**Item # 1**

Request DTC Modifications
Project Name LC SoBro Phase II

Staff Reviewer Buechler

**Staff Recommendation** *Approve with conditions.*

**Proposed North-South Cross Section**

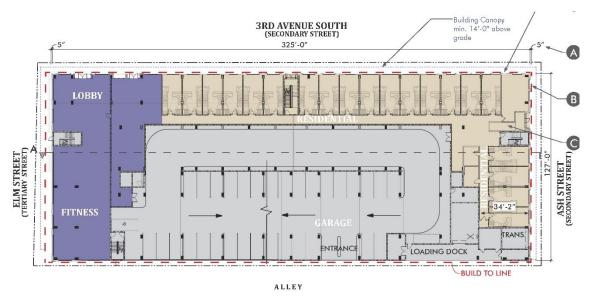
Along 3<sup>rd</sup> Avenue South the project proposes a 13-foot average ground floor height and along Ash Street the project proposes a 10-foot ground floor height. The requirement on both streets is a minimum 14-foot ground floor height. The DTC ground floor height requirement is for a storefront frontage, which is commonly used for commercial buildings; however, the proposed uses along 3<sup>rd</sup>

Avenue South and Ash Street are residential. The project proposes 2 of the levels of the above grade parking to be fully lined with apartments and the floor heights correspond to the levels in the parking structure. The units on the ground floor are two story units that are only accessed from the ground floor. The façade is designed to appear as the required minimum 14-foot height from the outside.

# Step-back – 3<sup>rd</sup> Ave South, Elm Street, and Ash Street

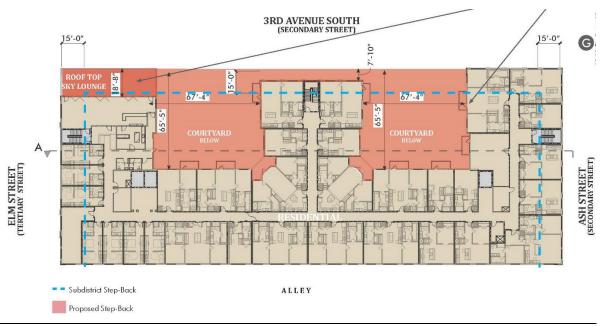
The DTC requires buildings 7 stories or greater to step back between the 4<sup>th</sup> and 7<sup>th</sup> stories. Along 3<sup>rd</sup> Ave South the façade width is approximately 325 feet; the building façade is broken up with two amenity decks on the fifth floor set back approximately 65 feet from the façade, and with residential units (on levels five-eight) arranged in an m-shape around the amenity decks. The modification along 3<sup>rd</sup> Ave South is for the units at the corner of 3<sup>rd</sup> Ave South and Ash Street that do not step back, the units at the corner of 3<sup>rd</sup> Ave South and Elm Street that step back on the eighth floor, and the units in the mid-point of the m-shape that step back 7'-10". This request is minor in nature. The amenity decks provide relief in the middle of the building and the block and break up the mass of the building so that there is not a long uninterrupted building wall fronting the street.

The proposed step-back modifications meet the intent of the DTC to maintain a low to mid-rise building wall along the street that does not overwhelm the street.
